Addendum 01

TO	Bidders & Plan Centers				
FROM	Jeff Schott, P.E.				
PROJECT	Sherman County Fair Grounds Arena				
SUBJECT	Addendum 001				
DATE	9/8/2021	PROJECT #	2021-009	MEMO #	PM-02

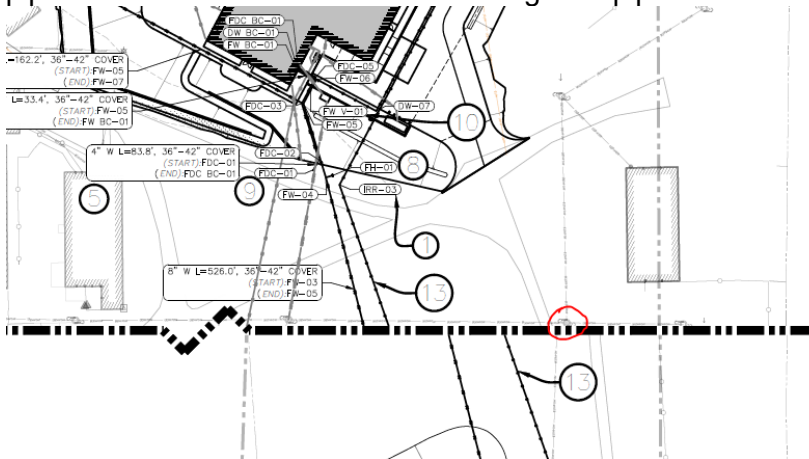
6. *Is a temporary supply of stock water required during construction?*

There is, apparently, a valve box near the power pole circled in red in the sketch below. Water will need to be maintained to this vault during construction. This vault feeds a line that runs down the hill to irrigate the existing midway area. Beyond this vault, to the north, the line maybe capped for construction. This is south of the main excavation area. We assume that this is a 2", 2 1/2" or 3" pipe to the north. Note also that the new fire line pipe will cross at least one unlocated irrigation pipe from this valve box to west
